Technical Note

| Copy | Ben Lippett (ARTC) | Reference | 2-0001-270-IHY-10-TN-0011_Rev 1 |
| Subject | Response to DPIE RFI regarding further modelling and assessment of velocities through culverts | | |

Table 5 Velocity results for culvert locations – scenarios assessed

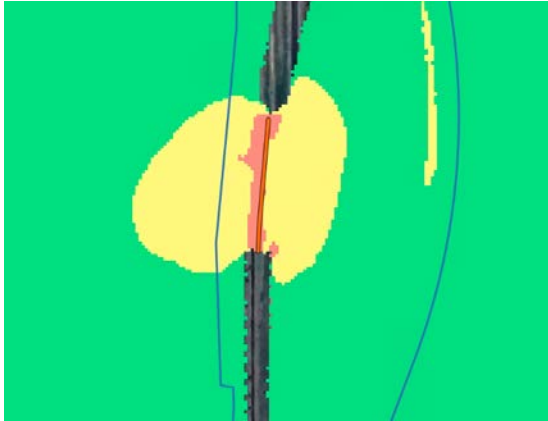
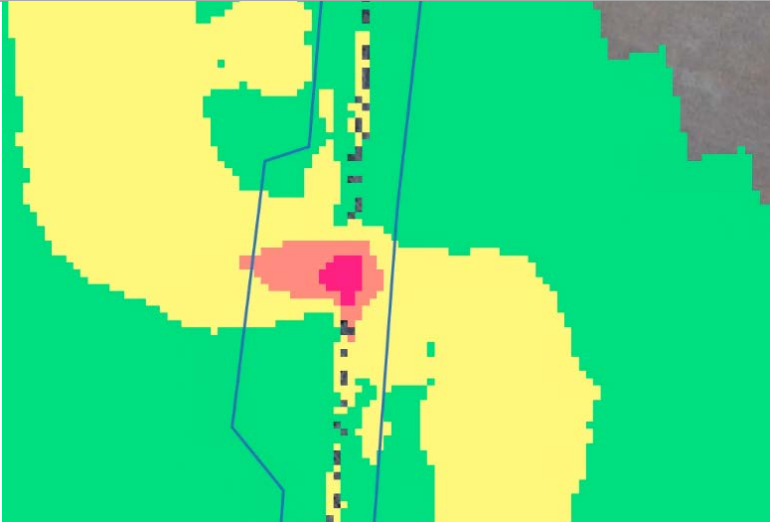
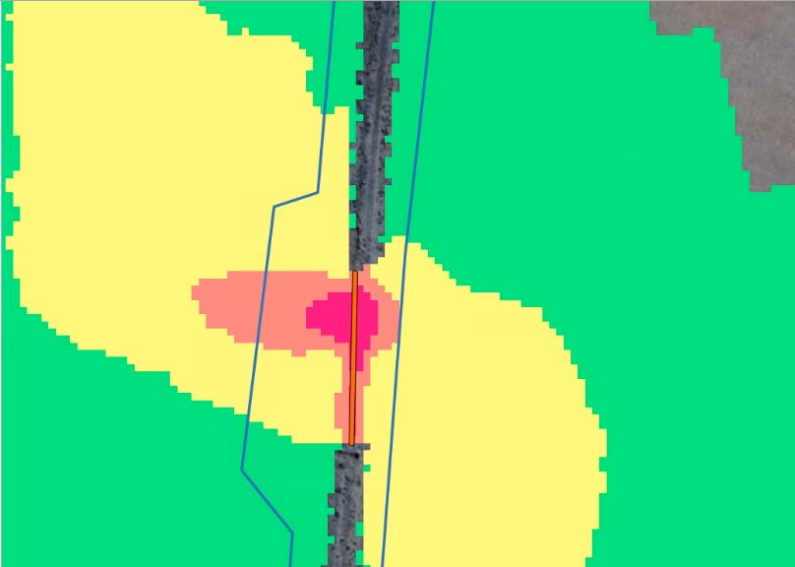
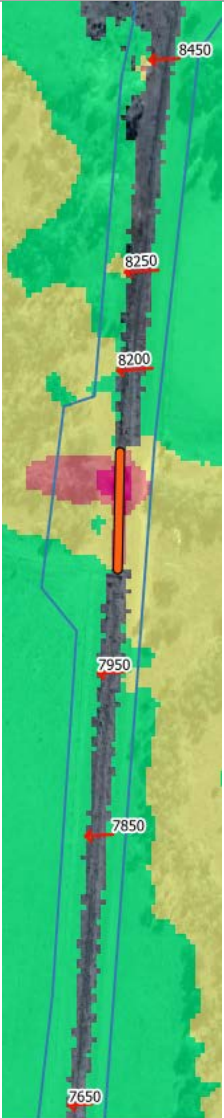
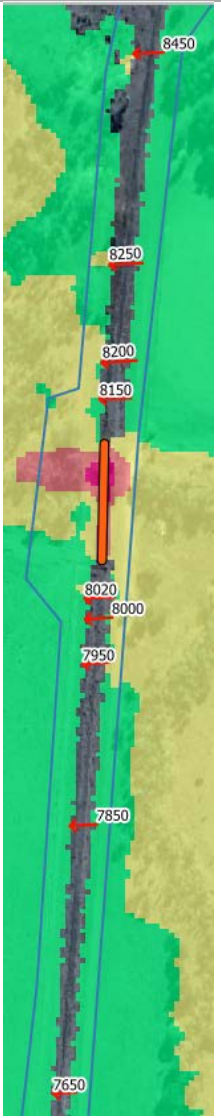
- There are two main culvert bank extents where the Reference Design does not comply with the erosion/scour potential QDL. These occur at:
 - The three banks of 35/1.2x0.9m RCBC around Ch 24.6 to 24.8km (near the Bruxner Way deviation)
 - The four banks of 25/1.2m RCP around Ch 22.8 to 23.8km

Based on the results in Table 3, the two culvert bank locations that did not comply with the QDL have been assessed with a range of engineering mitigation options tested as presented in Table 5.

The outcomes presented in Table 5 show that spacing of the culvert banks and minor additional culverts will ensure the design meets the scour/erosion QDL.

It should be noted that the embankment width currently shown for these culverts includes a passing loop and the actual embankment will be narrower with the impacts therefore all contained within the rail corridor boundary.

Figure 6 Afflux Map for Reference Design (SM1)

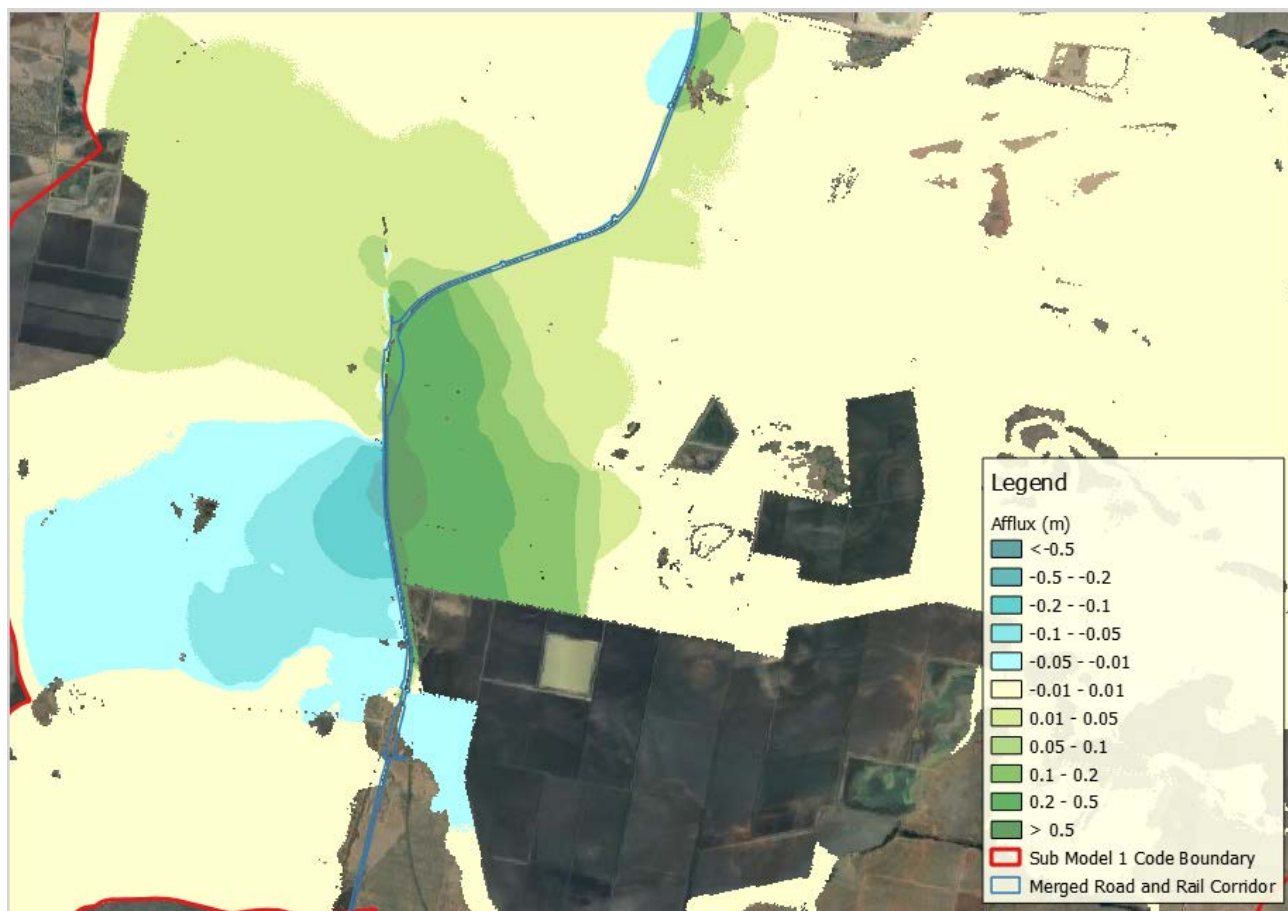
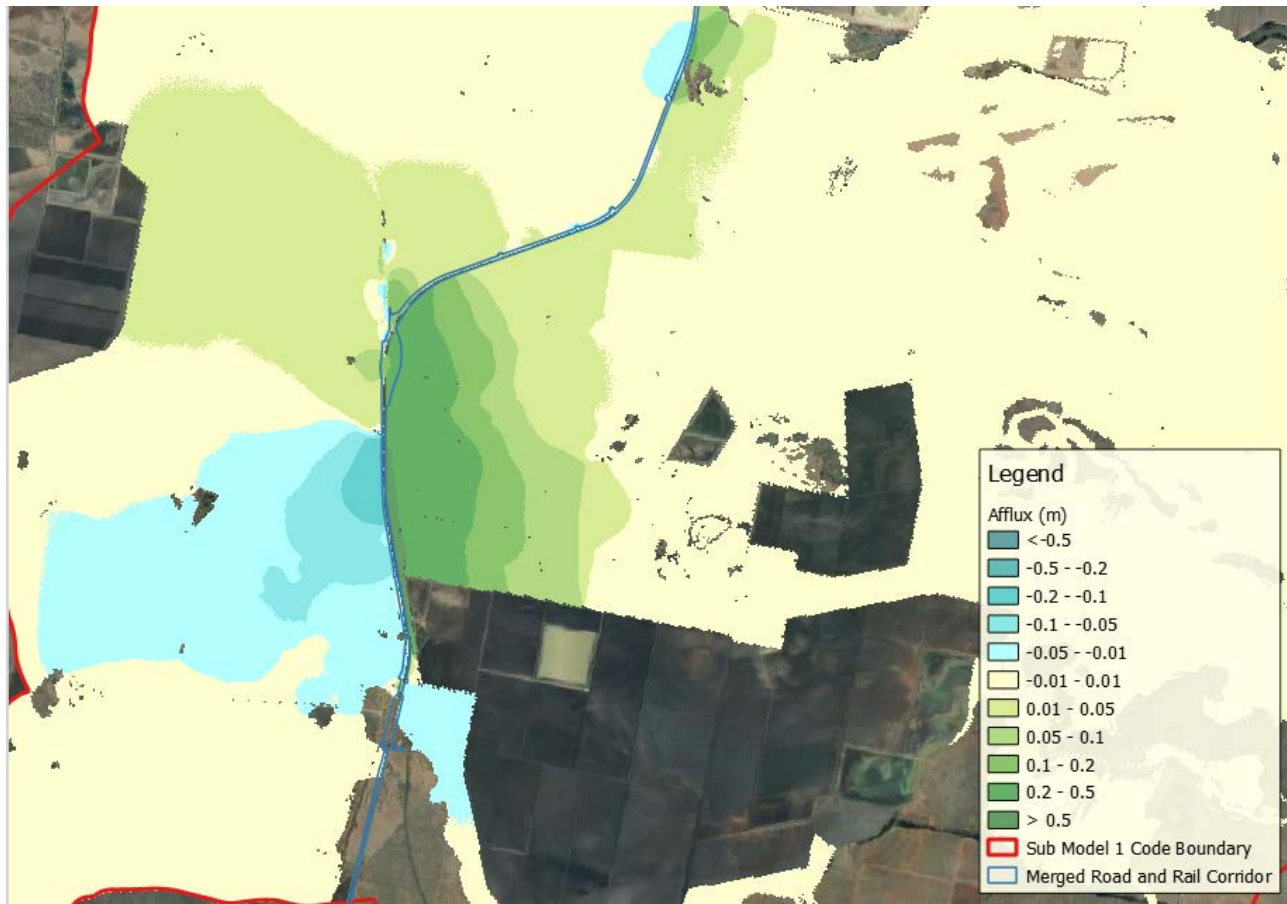
Figure 6 presents the 1976 flow scenario afflux for the Reference Design and Figure 7 present the updated afflux for the Mitigated Design as detailed in Section 6.2.3.

As can be seen with the mitigation measures in place there is a slight reduction in the afflux upstream of the alignment. The overall afflux pattern does not significantly alter.
